PLAN REVIEW COMMENTS FOR DP-12-25-020070

Town of Bluffton
 Department of Growth Management
 20 Bridge Street P.O. Box 386 Bluffton, South Carolina 29910
 Telephone 843-706-4522

Plan Type:	Development Plan	Apply Date:	12/23/2025
Plan Status:	Pending	Plan Address:	1181 A May River Road BLUFFTON, SC 29910
Case Manager:	Dan Frazier	Plan PIN #:	R610 039 000 097A 0000
Plan Description:	<p>A request by Nathan Sturre of Sturre Engineering, on behalf of property owner Trevor Wells for review of a Preliminary Development Plan application. The project consists of the construction of a two-story 8,000 SF mixed use building with associated infrastructure. The property is zoned Neighborhood Core and consists of 1.4 acres identified by tax map number 6610 039 000 097A 0000. (DP-06-25-019806) (Staff - Dan Frazier) STATUS: This item will be heard at the February 4, 2026 Development Review Committee meeting.</p>

WELLS MIXED USE

REV #	DATE	DESCRIPTION
	DATE	12/20/2025
	SHEET NAME	CIVIL DETAILS
	SHEET NO.	C-15

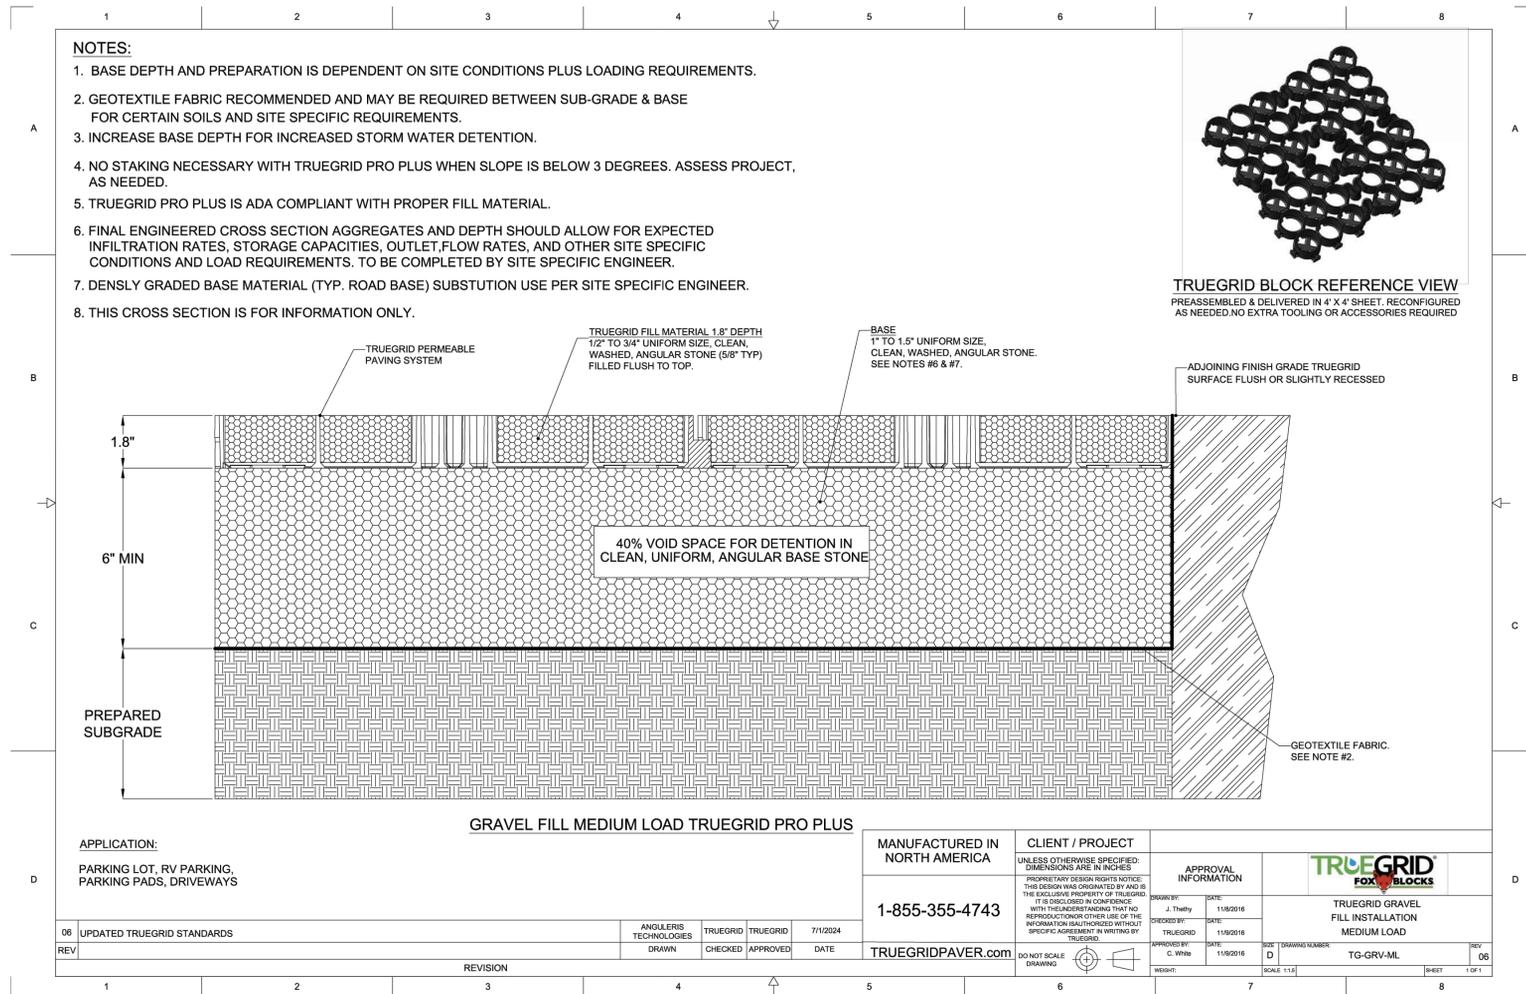
- Revise narrative to remove the "no state post-construction requirements" verbiage and "There is no additional onsite detention requirement per the SoLoCo Compliance Calculator."
- Revise narrative to state post-development peak discharge control for the 2, 10, 25, 50, and 100-year 24-hour storm events. (SWDM 3.5.2)
- The site must meet the compliance calculator TSS removal requirements, at a minimum. This is also a state requirement.
- Based on the geotechnical report, SHGW levels, and proposed pervious pavement detail, it does not appear that any form of pervious pavement will be feasible for this site.

DRAWING TITLE
SITE PLAN

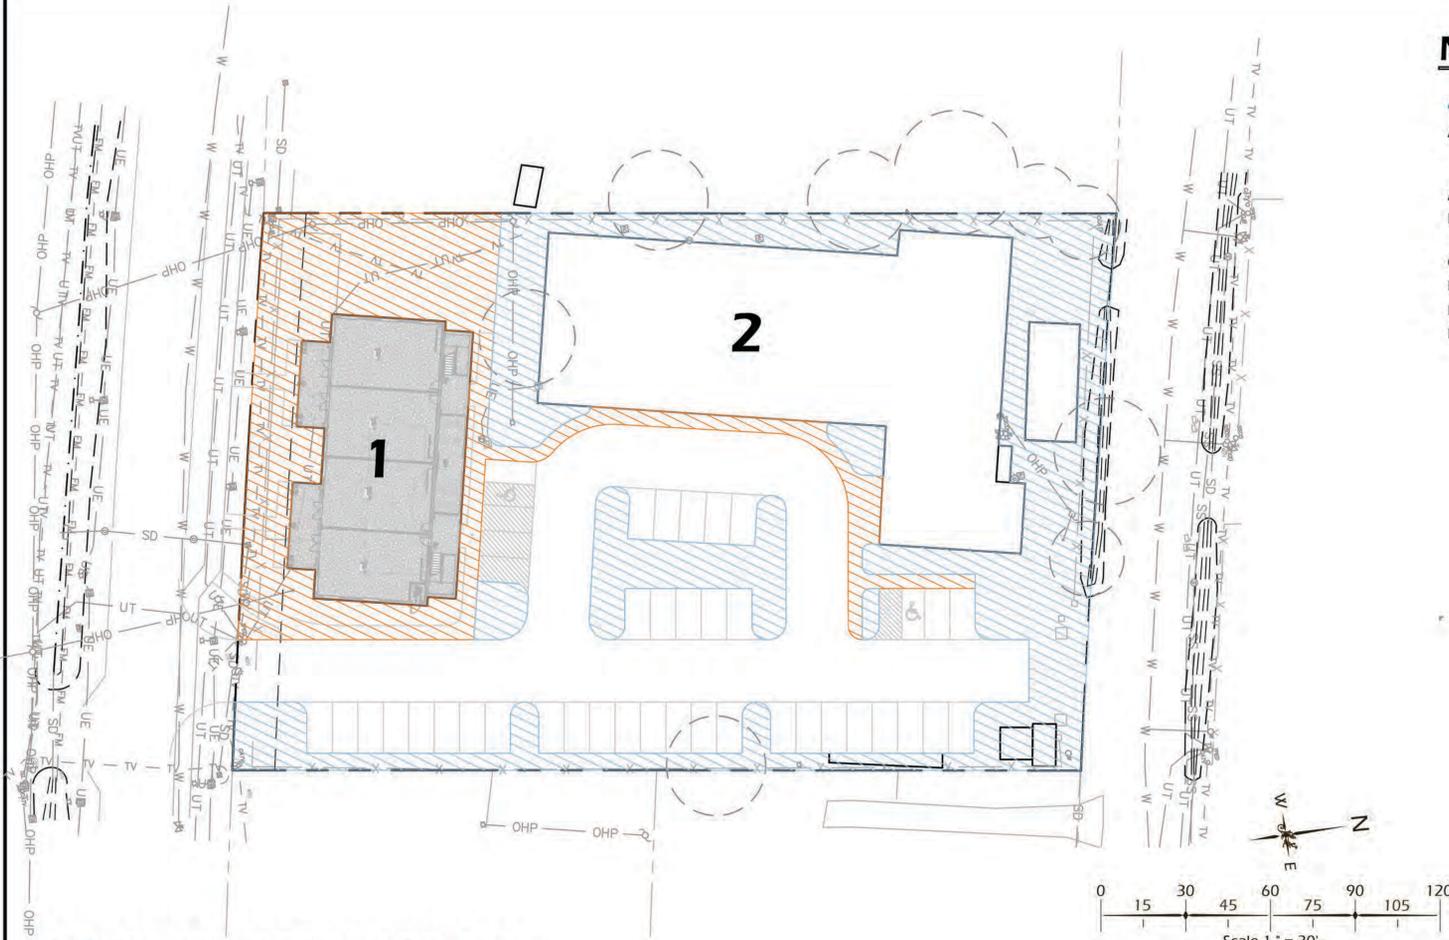
- Per UDO Table 5.11.3.C., provide data that justifies the proposed 1 parking space per 1,000 SF of Building 2 (Gymnastics studio) is necessary and reasonable.
- The proposed HC space adjacent to Building 1 cannot serve as a dedicated residential parking space. Mark it as a retail space, and identify one of the retail spaces as residential.
- Excluding HC Parking space, the dedicated residential spaces should be the 8 closest spaces to the residential stairwells.
- Confirm the 1st floor commercial/office entrance for public (front or back?).
